3.0 DESIGN OF STRUCTURES, COMPONENTS, EQUIPMENT AND SYSTEMS

3.2.1.4 *Technical Evaluation*

Figure 1. Comparison of the horizontal PBSRS calculated by the NRC staff, the horizontal PBSRS calculated by the applicant, and the Westinghouse CSDRS. NRC SCOR FIRS Site Response Confirmatory Analysis

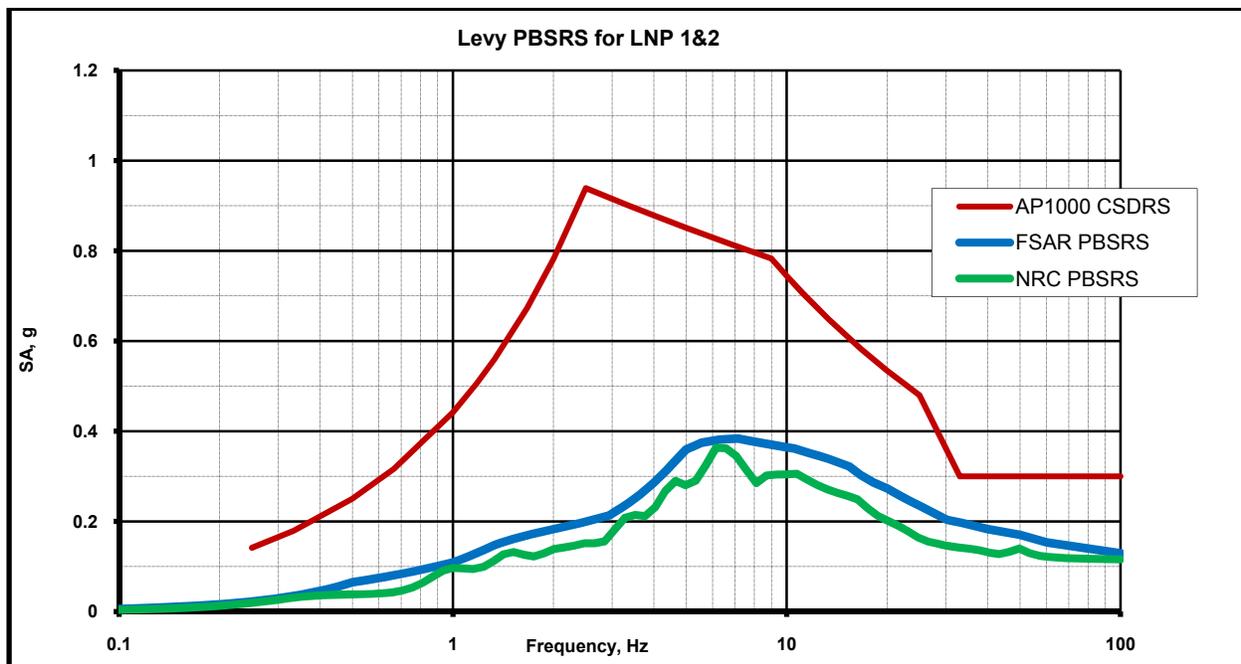
Figure 1 shows the comparison of the staff's calculated PBSRS with the PBSRS calculated by the applicant (FSAR Table 2.5.2-227 and FSAR Figure 2.5.2-297) together with the AP1000 CSDRS. The staff's PBSRS is enveloped by the applicant's and by the CSRDS. Therefore, the staff concludes that in the frequency range significant to a reactor's structures, systems, and components, there are no significant differences between the staff's and the applicant's calculated amplification functions and the PBSRS for the 10^{-4} and 10^{-5} hazard levels.

Figure 2. Comparison of the horizontal FIRS at the elevations of -7 m (-24 ft) and +3.3 m (+11 ft) calculated by the NRC staff, the horizontal FIRS at the same elevations calculated by the applicant, and the Westinghouse CSDRS.

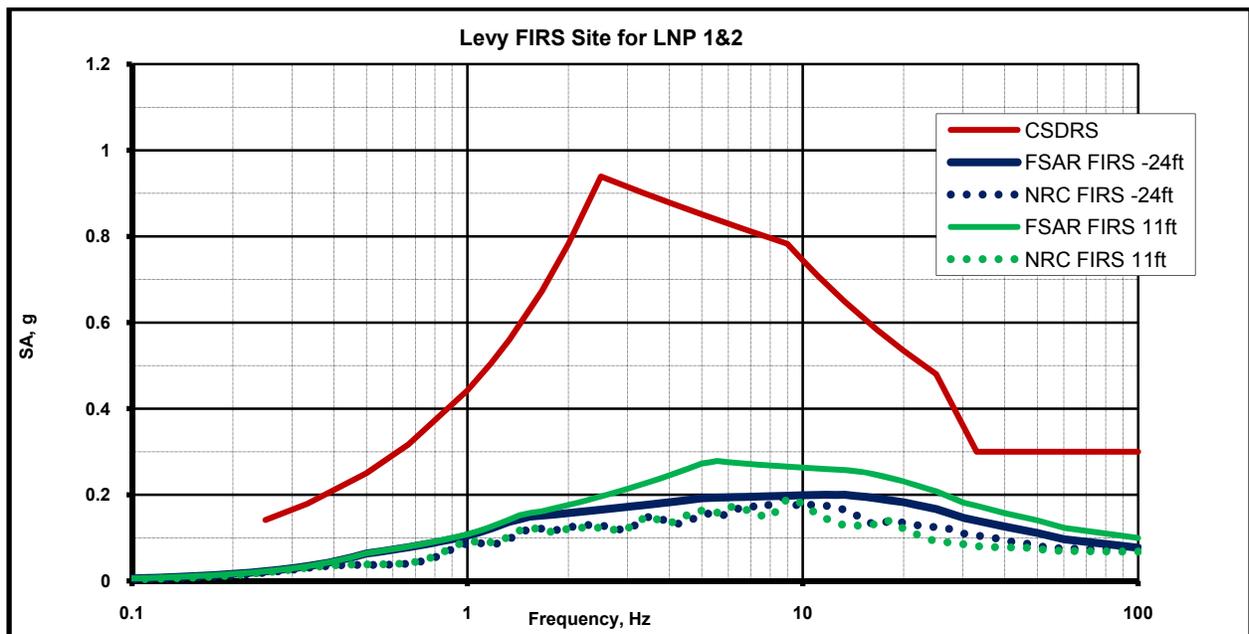
The staff's calculation of the FIRS at both elevations of -7 m (-24 ft) and +3.3 m (+11 ft) are enveloped by the applicant's FIRS and by the CSRDS. Therefore, the staff concludes that in the frequency range significant to a reactor's structures, systems, and components, there are no significant differences between the staff's and the applicant's calculated amplification functions and FIRS for the 10^{-4} and 10^{-5} hazard levels.

In addition, the staff identified that discreet shear wave velocities as measured by the P-S logger (Figures 2.5.2-247 and -248) are quite variable, ranging by wide margins from the average value within the zone of influence of the foundation. The staff questioned whether the variability of shear wave velocities across the footprint of the NI was consistent with the
